**Connell Hatch's Response to the  
Queensland Competition Authority's Draft  
Decision - October 2004**

14 December 2004  
Reference HD1501MI/  
Revision 0

# Outloading System Capacity

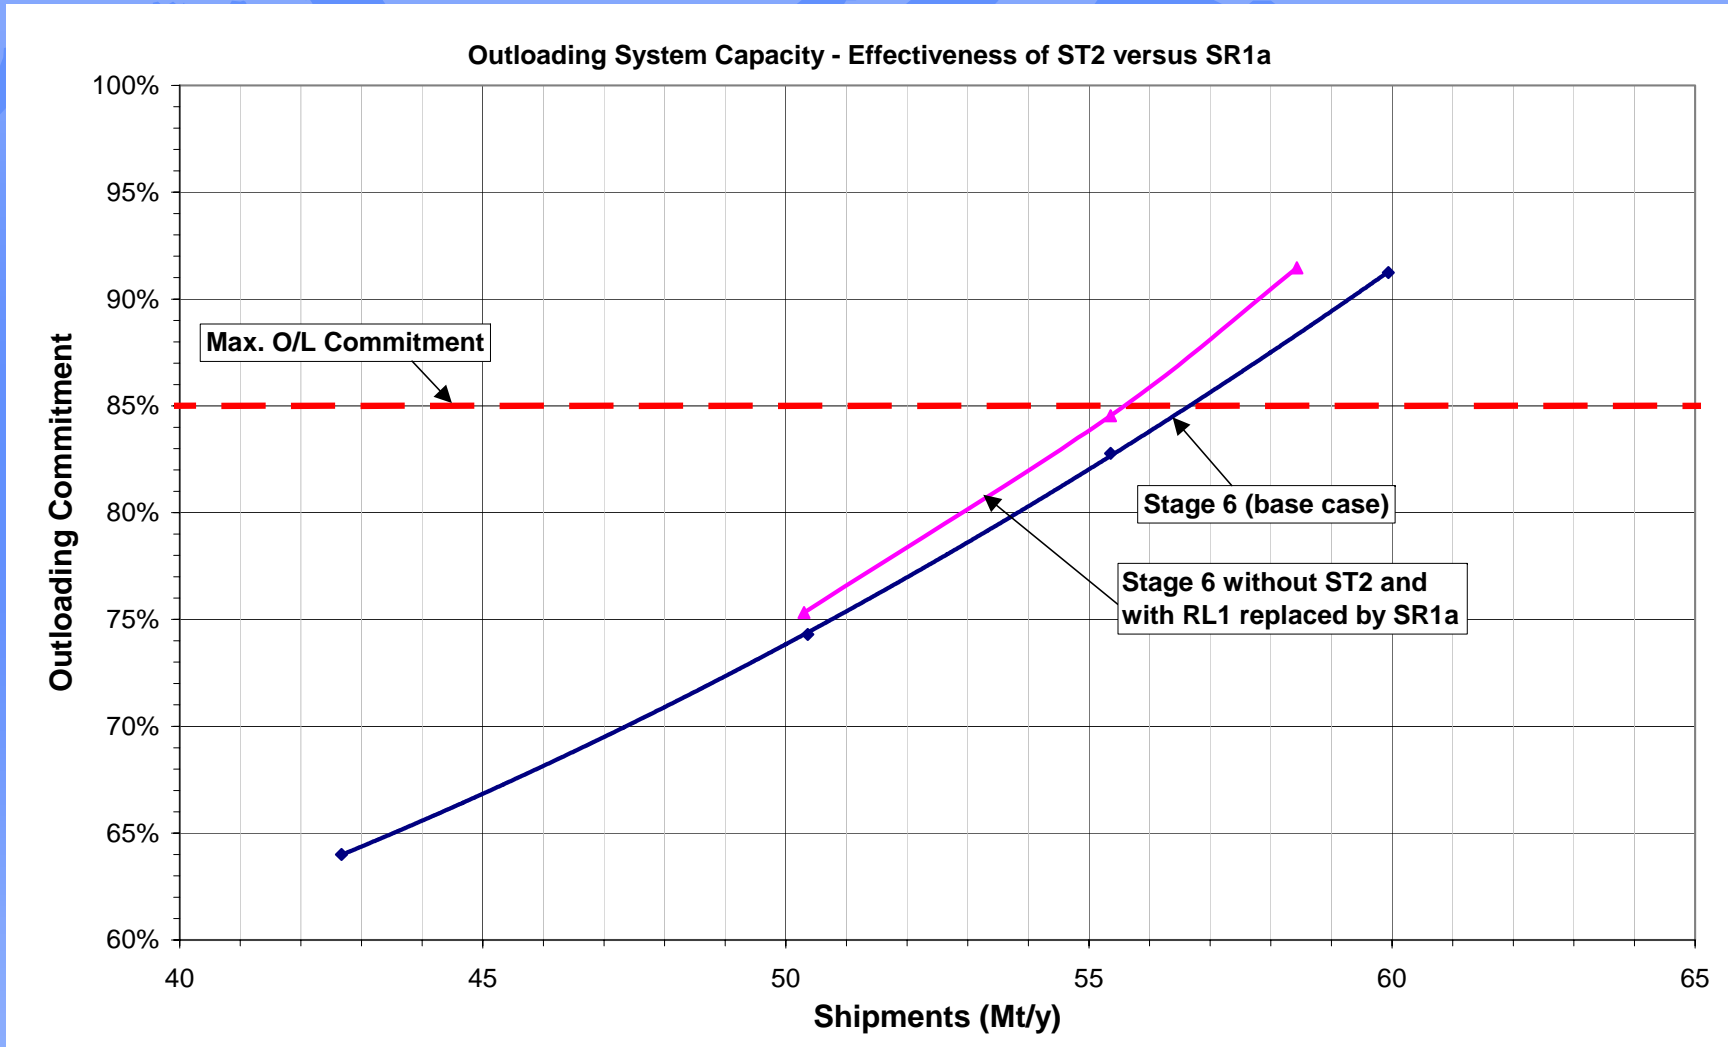
- ◆ Simulation runs were made for the two alternatives:
  - Stage 6, the base case, with ST2
  - Stage 6 with RL1 replaced by SR1a and with ST2 eliminated
- ◆ Simulation runs were made at 50, 55, and 60 Mt/y to determine the throughput at which the terminal outloading system became a bottleneck (taken to be 85% commitment).

- ◆ Terminal outloading capacity for Stage 6 is 56.5 Mt/y
- ◆ The alternative stockyard arrangement with RL1 replaced by SR1a and with ST2 eliminated was found to reduce terminal outloading capacity by 1.0 Mt/y to 55.5 Mt/y.
- ◆ Gross loading times were increased by the alternative stockyard by an average of 1.5 hours per ship.
